Agenda Report

July 11, 2016

TO: Honorable Mayor and City Council
FROM: Planning & Community Development Department
SUBJECT: PREDEVELOPMENT PLAN REVIEW OF A 115-UNIT MIXED USE PROJECT LOCATED AT 711 E. WALNUT STREET

Site Plan (Ground-Level Plan):

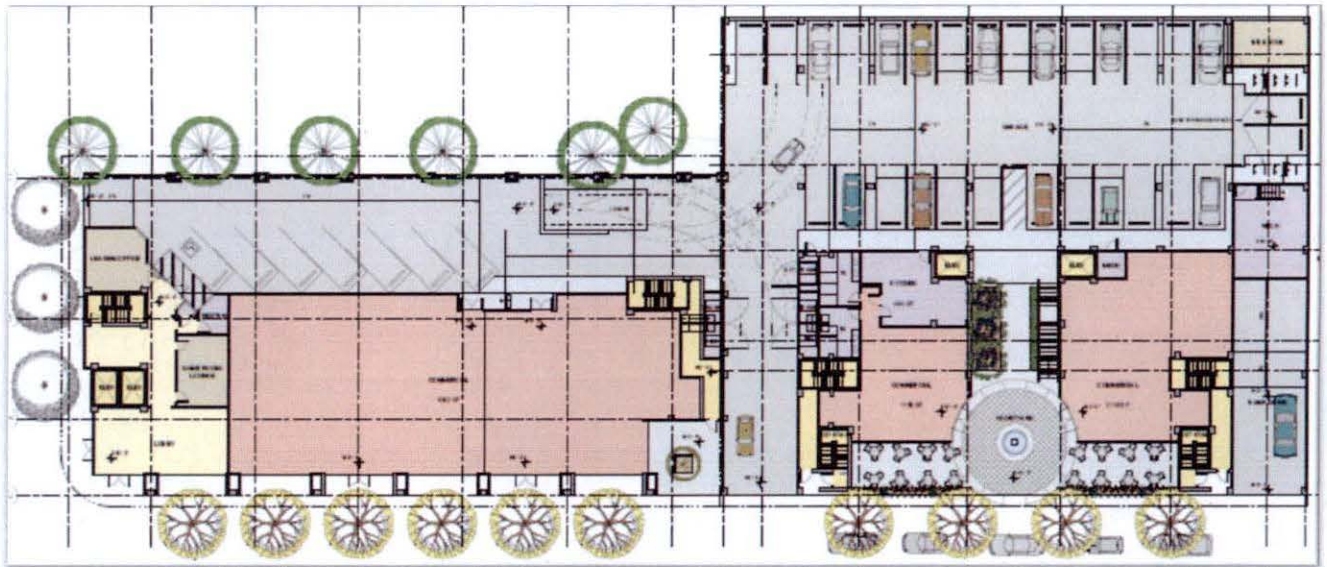
Based on the plans submitted, the project would not meet the setback requirement along Walnut Street because the building frontage is designed to be away from the street more than five feet due to the bulky posts in front of the west half of the façade; the outdoor dining area along the frontage of the east part of the building; and the building separation and a tree well by the central driveway. The project needs to be redesigned to meet the setback requirements unless an additional concession or variance application is submitted.

1. Although separated at either end of the site, the use of 40 feet of street frontage for vehicular access is undesirable. Explore ways to consolidate vehicular access to a single driveway along Walnut Street, possibly by locating access to ground-level commercial parking along El Molino Avenue only. The Commission further recommended removal of the central driveway along Walnut Street.

Subterranean Garage Driveway Ramp: In order to provide sufficient sight distance for pedestrians along Walnut Street frontage, the proposed driveway ramp to the subterranean garage, from the property line to the first 20 feet north shall be sloped at two percent or less.
